Plugging Program for Bonita Canyon #1:

Pertinent Data Sheet

Well Name: Bonita Canyon #1
Footage: 1185' FNL and 950' FEL
Location: Section 23, T23N, R4W
County: Sandoval County, NM
API#: 30-043-20954

Wellbore Diagram
Bonita Canyon #1
NE/4 Sec. 23, T23N, R4W
Sandoval Co., NM
API #30-043-20954

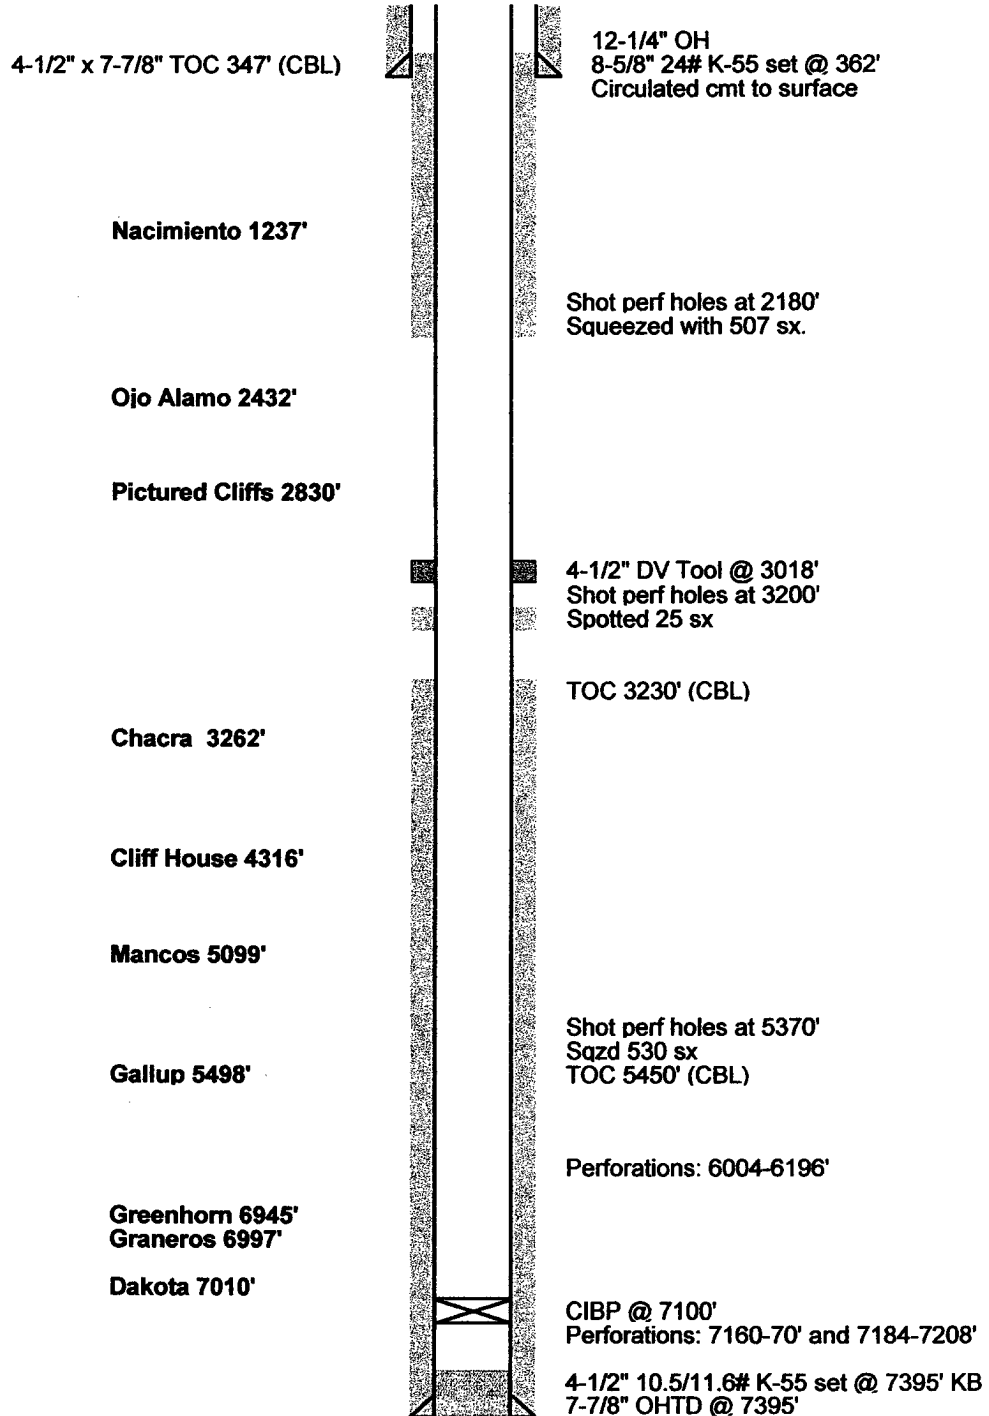
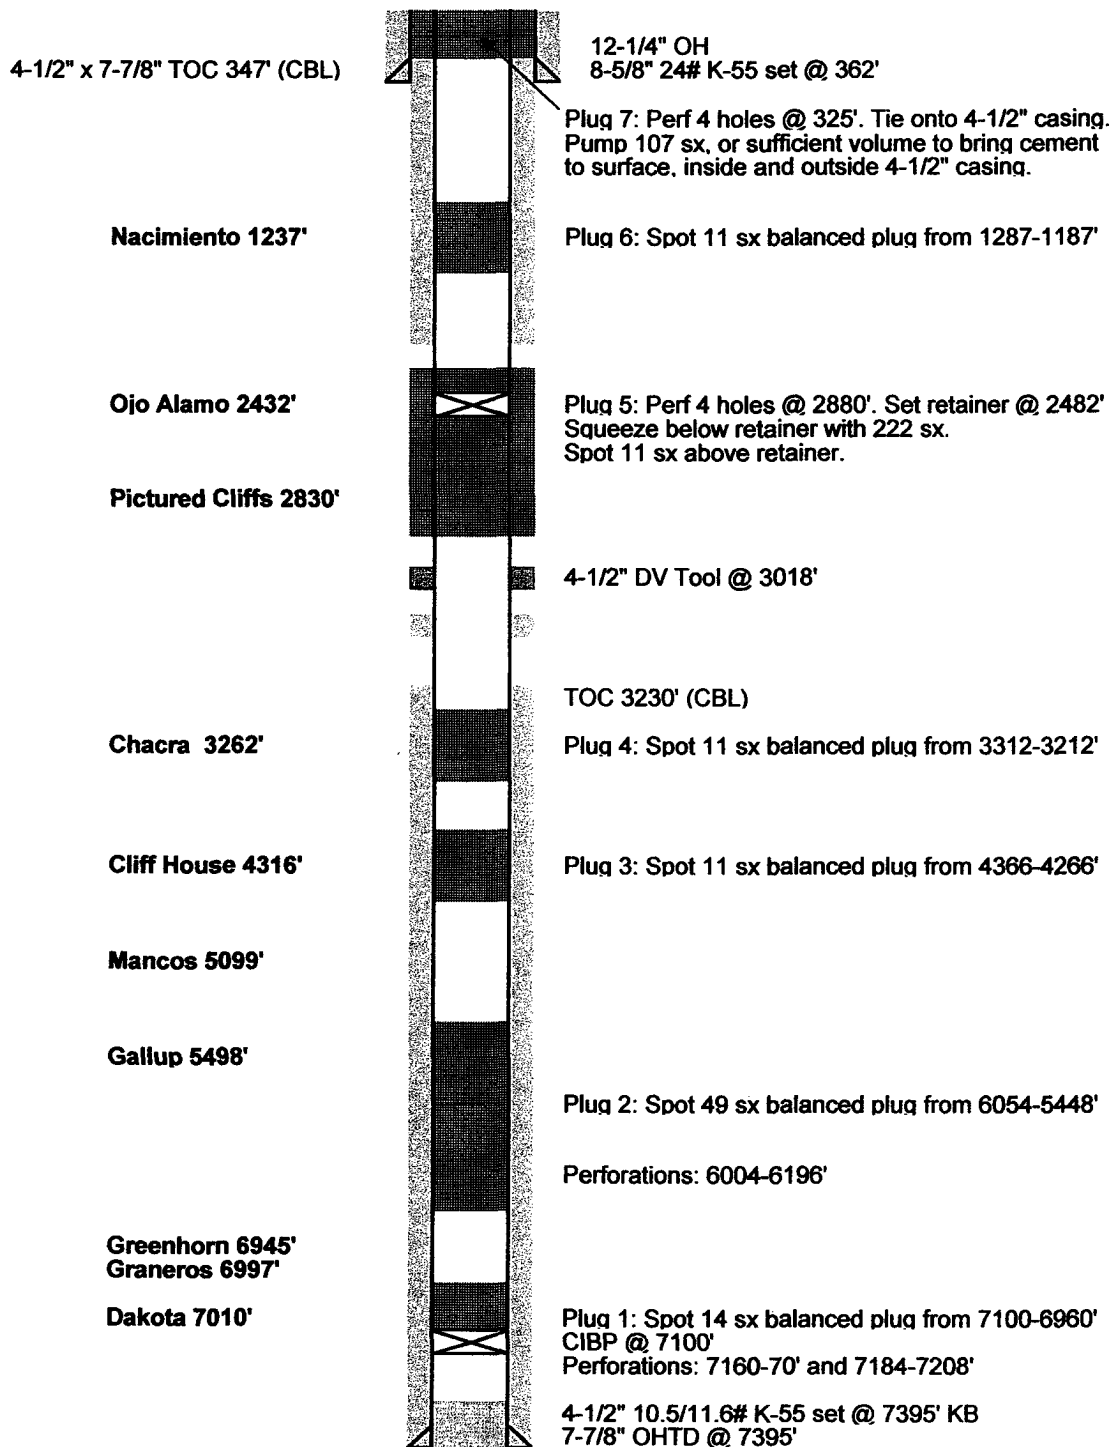
Plug 4: Spot 11 sack balanced plug to cover 100' across Chacra top from 3312-3212'. Pull up and reverse circulate with 2 tubing volumes of water. *Unnecessary*

Plug 5: Perf 4 holes at ^{2830'} 2880'. RIH with 4-1/2" retainer and set at 2482'. Squeeze below retainer with 222 sacks, and spot 11 sack plug on top of retainer to cover Pictured Cliffs, Fruitland, and Ojo Alamo tops from 2880-2382'. Pull up and reverse circulate with 2 tubing volumes of water.

Plug 6: Spot 11 sack balanced plug to cover 100' across Nacimiento top from 1196'-1096' 1287-1187'. Pull up and reverse circulate with 2 tubing volumes of water.

^{plug 418'-318'} Plug 7: Perf 4 holes at ^{310'} 325'. Tie onto 4-1/2" casing. Pump 107 sacks, or sufficient volume, to bring cement to surface, inside and outside 4-1/2" casing.
